**SUBMITTAL TO THE BOARD OF SUPERVISORS
COUNTY OF RIVERSIDE, STATE OF CALIFORNIA**

SUBJECT: Accept the Low Bid and Award the Contract for the Construction of Exchange Club Park Frontage Improvements Project at Mayberry Avenue and Fairview Avenue in the Community of Valle Vista. 3rd District; [\$985,300- Total Cost]; Local Funds 100%

During the advertisement period, two addenda were issued to all registered plan holders as a supplement to the plans and specifications. Bidders were required to acknowledge and take into account the issued addenda on their contractor Bid in order to be considered for award. The addenda were issued to clarify and modify the approved contract documents. The addenda are attached and designated as Addendum No. 1 and Addendum No. 2.

36" x 36"
CATCH BASIN

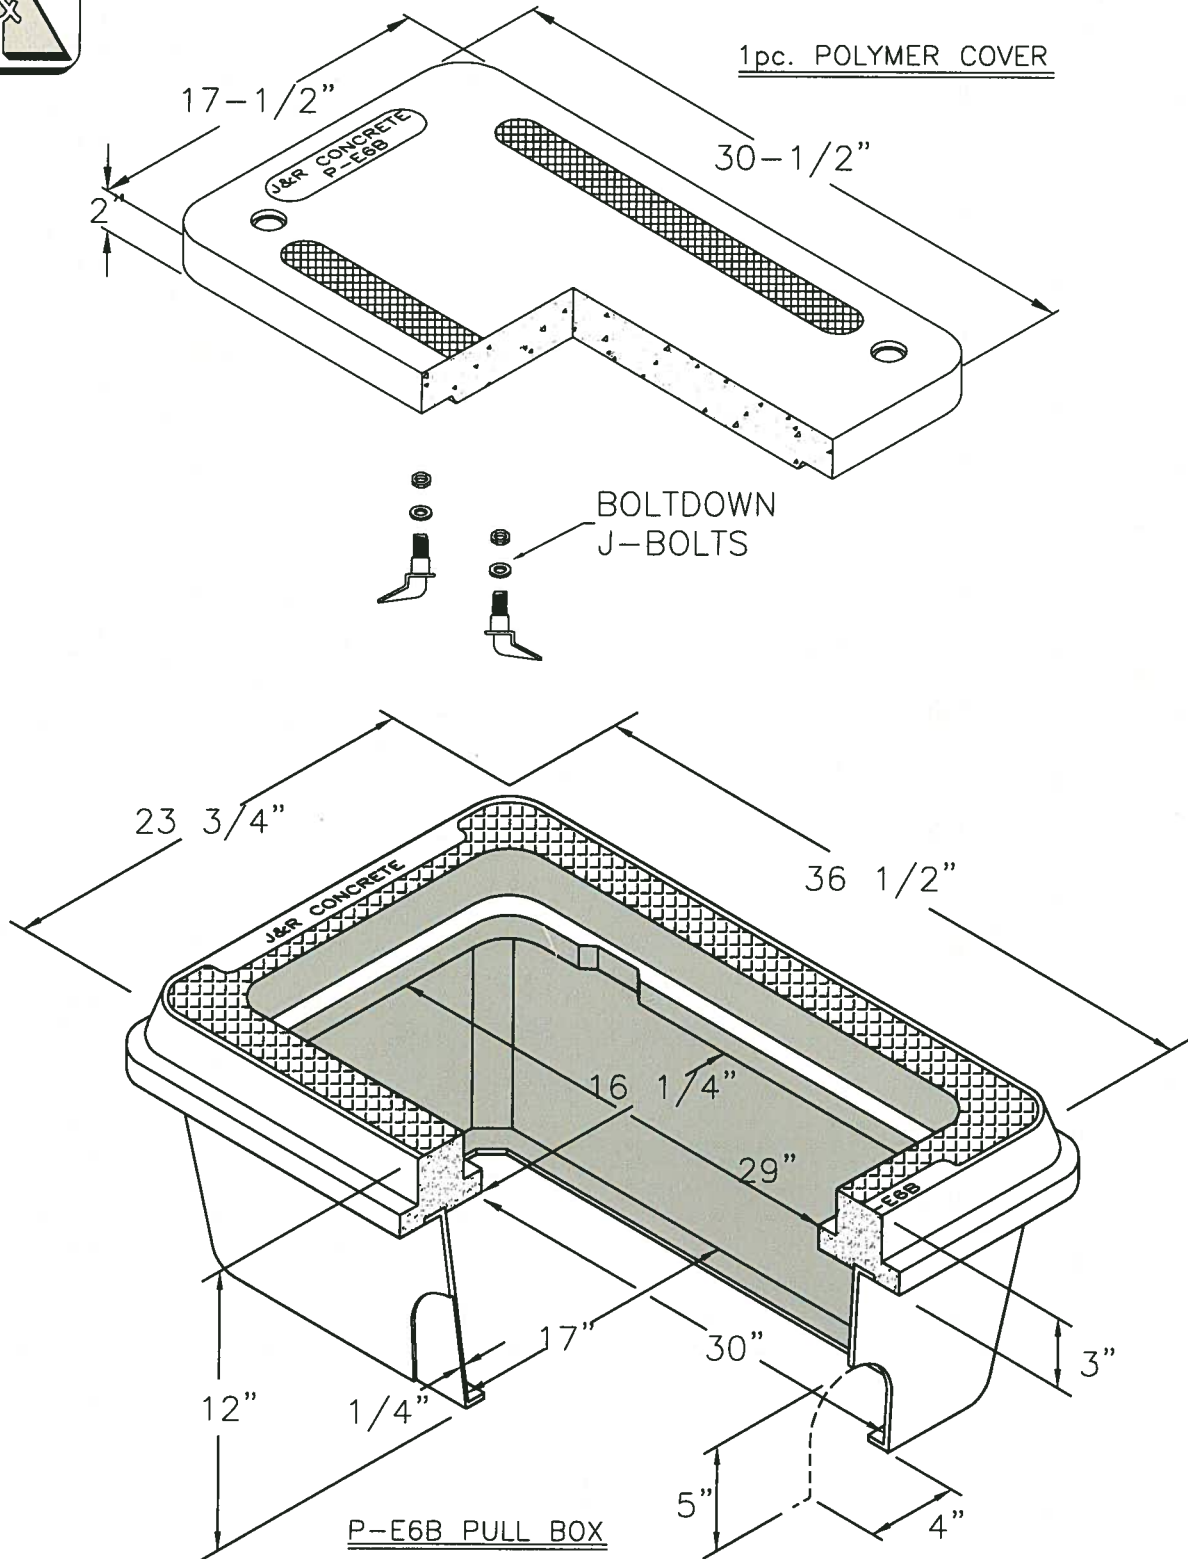
Item 25: Addition of Reference Drawings. Refer to Appendix B, Reference Drawings, of the Special Provisions. The following reference drawings are added by **Attachment "B"** and made part hereby:

- County Std. 403 for Curb Ramp-Case C, "T" Intersection with Sidewalk at Curb
- Brooks Products, Std. 3636 CV, 36" x 36" Catch Basin
- J&R Concrete Products, Std. P-E6B, Electrical Pull Box
- On-Site Detail – Accessible Curb Ramp
- On-Site Detail – Accessible Entry Signage
- On-Site Detail – Accessible Parking Stall
- On-Site Detail – Accessible Parking Signage
- On-Site Detail – Accessible Van Parking Signage
- On-Site Detail – Painted Accessible Parking Symbol
- On-Site Detail – Truncated Dome Tiles
- VWR&PD Std. LC-02 for Concrete Flatwork
- VWR&PD Std. LC-03 for Concrete Rebar and Joints
- VWR&PD Std. LC-12 for Tubular Steel Fencing
- VWR&PD Std. LC-13 for Tubular Steel Gate

**P-E6B Polymer Series / 17" x 30"
Electrical Pullbox w/ Fiberglass
Body & Polymer Concrete Ring**

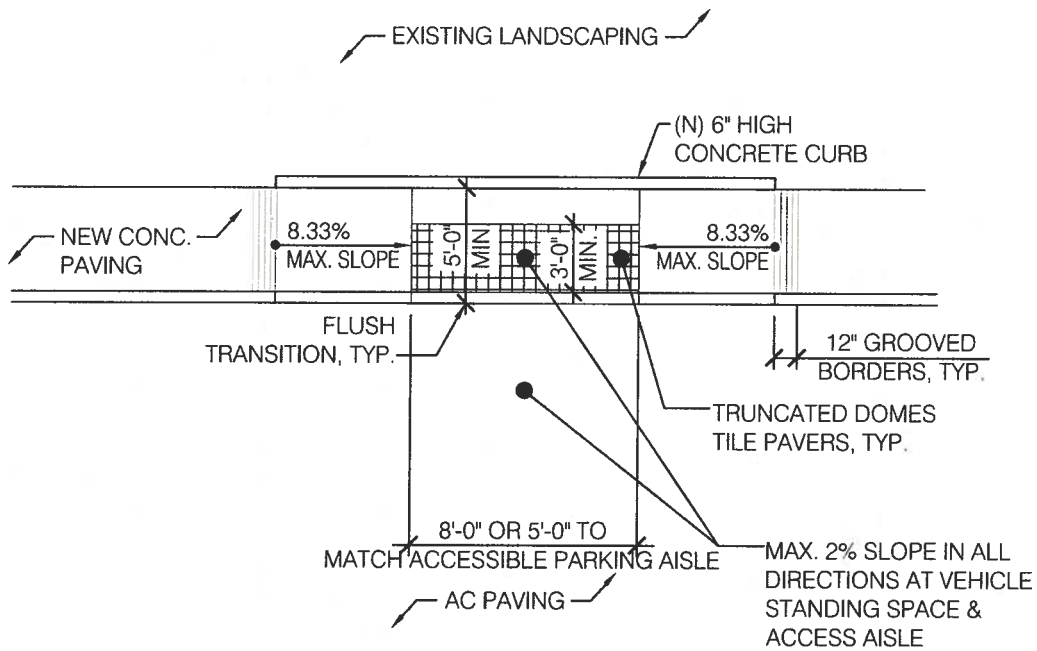
Pull boxes (shown on the plans) will be required at the ends of the PVC conduit installed. Pull boxes must be 17"x30" electrical pull boxes with fiberglass body and polymer concrete ring as manufactured by J&R Concrete Products, Std. P-E6B, or approved equal. Full compensation for furnishing and installing these pull boxes shall be considered as included in the linear feet contract price paid for the different types of conduit included in the bid items list.

NOTE

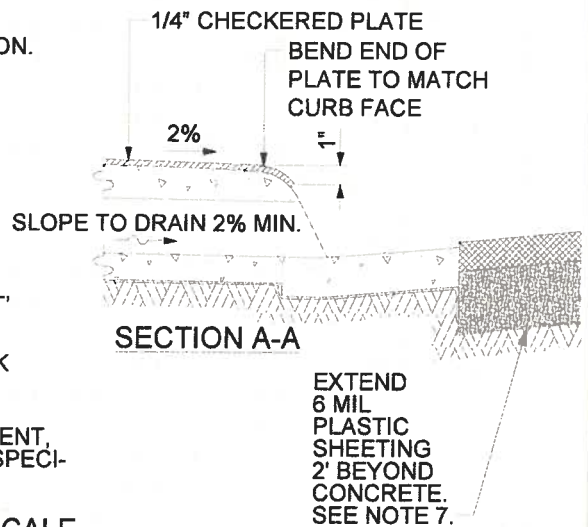
Item 4: Add Construction of Under Sidewalk Drain. Refer to plans sheet 3 of 11.

On Sheet 3 of 11, the following note is added at Station 17+05 (South Side of Mayberry Avenue):

- ① UNDER SIDEWALK DRAIN TO BE CONSTRUCTED AT 90°. VARIATIONS FROM 90° REQUIRE THE APPROVAL OF THE DIRECTOR OF TRANSPORTATION.
- ② SLOPE TO DRAIN TO ONE SIDE.
- ③ ALL EXPOSED METAL PARTS TO BE GALVANIZED AFTER FABRICATION.
- ④ 1 1/2" X 1 1/2" X 1/4" "L" FRAME WITH 3/8" X 1/4" STEEL STRIP WELDED TO FRAME.
- ⑤ CHECKERED PLATE SHALL BE GALVANIZED STEEL, MAXIMUM WIDTH 36".
- ⑥ FASTEN WITH 1/4" COARSE-THREAD COUNTERSINK METAL SCREWS AT 12" O.C..
- ⑦ WHEN ABUTTING SOIL HAS A HIGH SULFATE CONTENT, SPECIAL CONSIDERATIONS ARE REQUIRED. SEE SPECIFICATIONS (SECTION 16.04).
